# ALERT SERVICE BULLETIN REVISION NOTICE

NON-MODIFICATION SERVICE BULLETIN — ENGINE — DISK STAGE 6, LOW PRESSURE  
TURBINE (LPT) — REMOVAL OF SUSPECT DISKS

Turbojet Engine Service Bulletin No. V2500-ENG-72-A0697 Revision No. 1 dated November 27, 2018.

# V2500-ENG-72-A0697

Figure 1

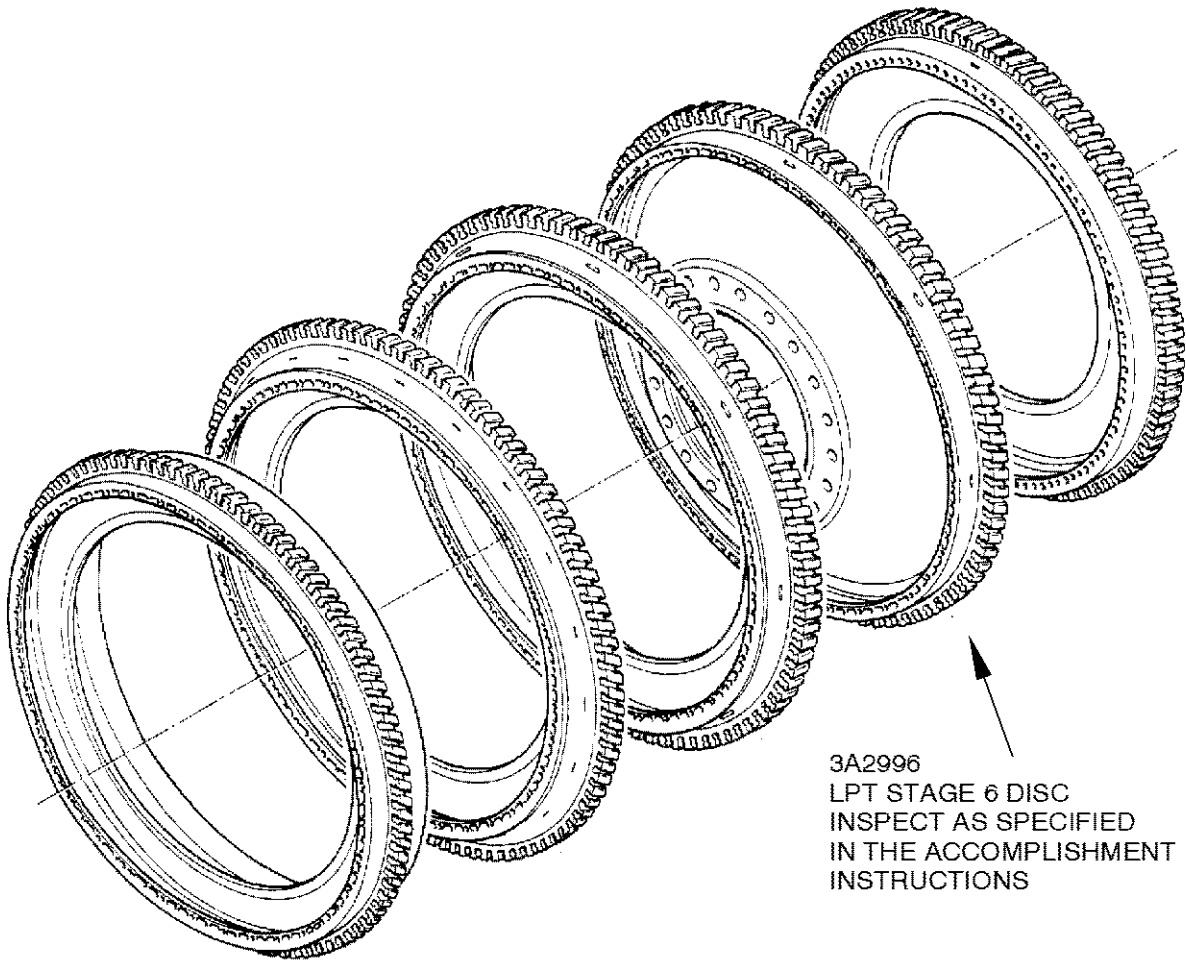
1. Disassemble the engine sufficiently to remove the LPT Stage 6 Disk, PN 3A2996. See Figure 1.
  - A. Disassemble the engine sufficiently to remove the LPT module assembly as specified in Reference 5, Engine Manual, Task 72-00-50-020-000.

2. Replace the suspect LPT Stage 6 Disk, PN 3A2996.
  - A. Replace the suspect LPT stage 6 disk with a non-suspect LPT Stage 6 Disk, PN 3A2996.
  - B. The suspect LPT Stage 6 Disk, PN 3A2996, identified by serial number in Table 1 must be scrapped and it must be ensured that the re-utilization is 100% excluded. A photograph or digital image of the mutilated LPT stage 6 disk and a copy of the scrap tag, countersigned by the local IAE representative, must be provided to IAE Warranty.
